Entergy Nuclear Operations, Inc.  
Palisades Nuclear Plant  
27780 Blue Star Memorial Highway  
Covert, MI 49043  
Tel 269 764 2000

SUBJECT: License Amendment Request for Spent Fuel Pool Region I Criticality

Palisades Nuclear Plant  
Docket 50-255  
License No. DPR-20

### DESCRIPTION OF REQUESTED CHANGES

**Region 1B Patterns for Four or Fewer Face Adjacent Assemblies in a Row**

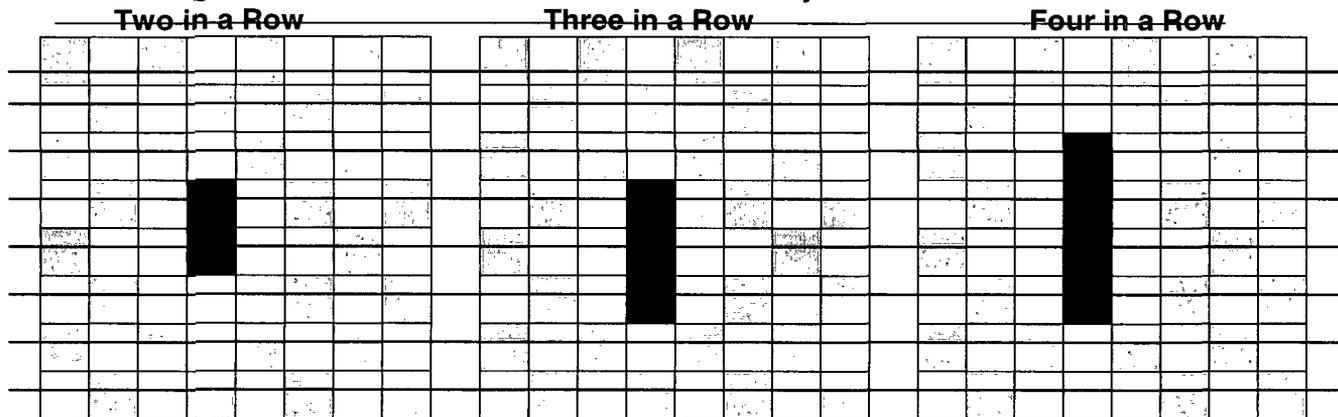
g. Region 1B is defined as the Region I storage racks located in the main spent fuel pool with face adjacent fuel that is surrounded by empty face adjacent cells. Region 1B fuel is limited to those assemblies having a nominal planar average U-235 enrichment of less than or equal to 4.34 weight percent. Region 1A cells that are diagonally adjacent to Region 1B may contain fuel assemblies provided conditions of Section 4.3.1.1f, 4.3.1.1g.1 and 4.3.1.1g.2 are met. Restrictions for non-fissile bearing components are described in section 4.3.1.1j below. Additional geometric conditions on Region 1B are:

1. Up to four face adjacent fuel assemblies in a single contiguous row are allowed as shown in the figures below. All other face adjacent cells shall be empty or contain non-fissile bearing components as described in section 4.3.1.1j below.

“Region 1B is defined as a subsection of the Region I storage racks located in the main spent fuel pool and is subject to the following restrictions. Fuel assemblies (or fissile bearing components) located in Region 1B shall be in a maximum of three-of-four loading pattern consisting of three fuel assemblies (or fissile bearing components) and one empty cell. Fuel assemblies in Region 1B shall meet the enrichment dependent burnup restrictions listed in Table 3.7.16-2. Designated empty cells may contain non-fuel bearing components in accordance with Section 4.3.1.1k.2. below;”

**Region 1B Patterns for Three in an L**

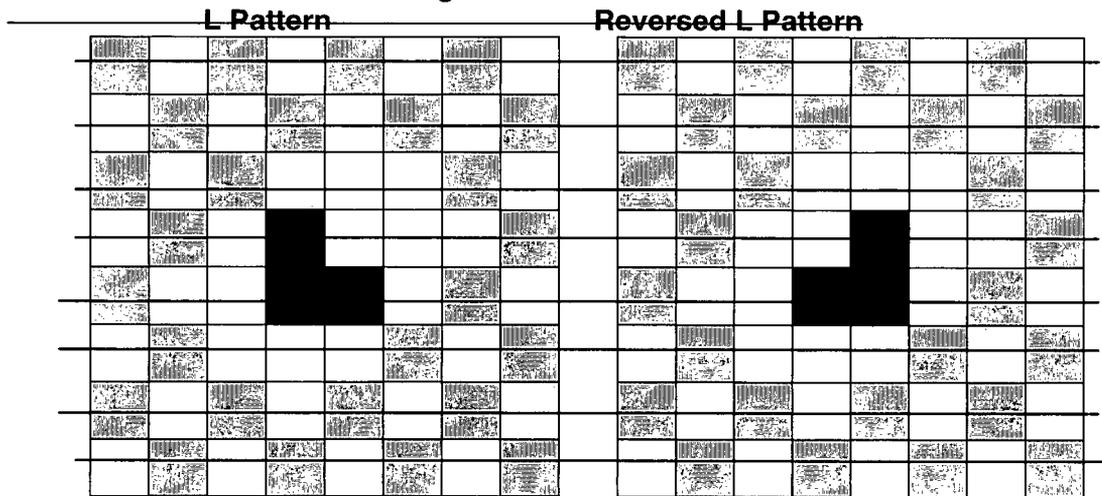
2. Three face adjacent fuel assemblies forming an L pattern are allowed as shown in the figures below. All face adjacent cells surrounding the two-by-two block containing the L pattern shall be empty or contain non-fissile bearing components as described in section 4.3.1.1j below;
